# UNITED STATES PATENT AND TRADEMARK OFFICE

APPLICATION NO.	FILING DATE	FIRST NAMED INVENTOR	ATTORNEY DOCKET NO.	CONFIRMATION NO.
10/773,953	02/06/2004	Stan Routt	ROUTTRUBIO-1	7328

<b>Office Action Summary</b>	<b>Application No.</b> 10/773,953	<b>Applicant(s)</b> ROUTT ET AL.	
	<b>Examiner</b> Debra S. Meislin	<b>Art Unit</b> 3723

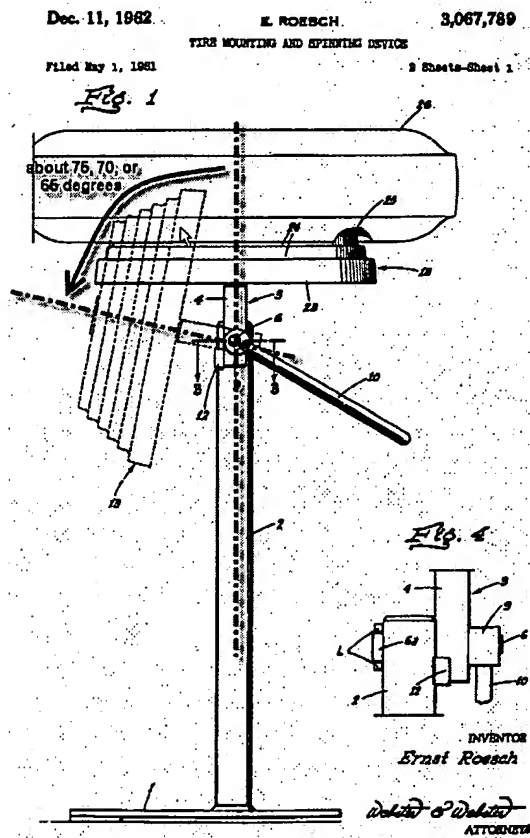
With respect to claims 2-4, Roesch discloses an angle of pivot of about 75, 70, or 60 degrees as shown in figure 1, below.
